Commenter ID	Date of Letter, E-mail or Comment	Commenter (and Association, if Applicable)
A	July 11, 2016	Carlsbad Environmental Monitoring and Research Center (CEMRC), submitted by Russell Hardy, Ph.D., Director
B	July 17, 2016	Rocky Mountain Peace and Justice Center, submitted by LeRoy Moore, Ph.D.
C	July 18, 2016	Carlsbad Mayor's Nuclear Task Force, submitted on behalf of John Heaton and Dave Sepich
D	August 4, 2016	Carlsbad Department of Development (CDOD) Resolution submitted by Russell Hardy, Ph.D. and Danny Cross, CDOD
E	August 4, 2016	Danny Cross
F	August 4, 2016	Tonk Chester, SPHR, SHRM-SCP
G	August 4, 2016	Bill Vandergriff
H	August 5, 2016	New Mexico State Representative Cathrynn Brown
I	August 8, 2016	John Waters
J	August 8, 2016	The WIPP Permittees, on behalf of Todd Shrader, CBFO Manager and Philip Breidenbach, NWP Project Manager
K	August 8, 2016	Deborah Reade
L	August 8, 2016	Basia Miller, Ph.D.

Subject: Comments on the June 3, 2016, Class 2 Permit Modification Request:
"Revise the *RCRA Contingency Plan* and Associated Emergency Response
Personnel Training and Active Room Ventilation Flow Rate" for the Waste
Isolation Pilot Plant Hazardous Waste Facility Permit Num

Figure D-1
WIPP Surface Structures

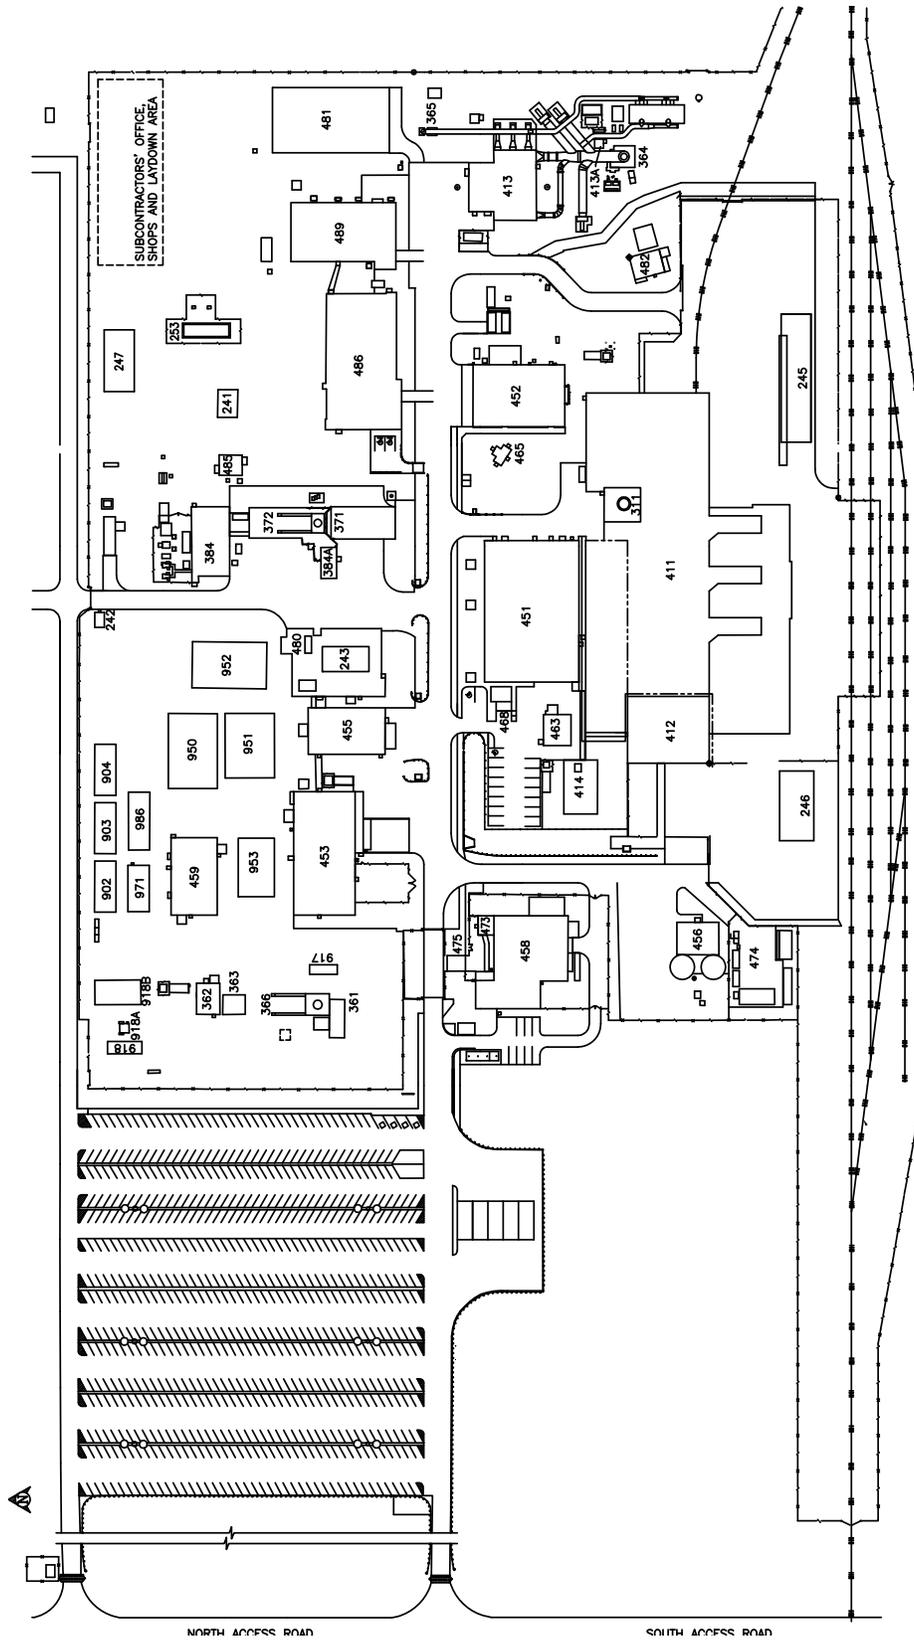
13. The Permittees propose to add the Waste Handling Building number (411) to Figure D-1 and the revision to Figure D-6 from the PMR. These revised Figures are provided in Attachment 2.
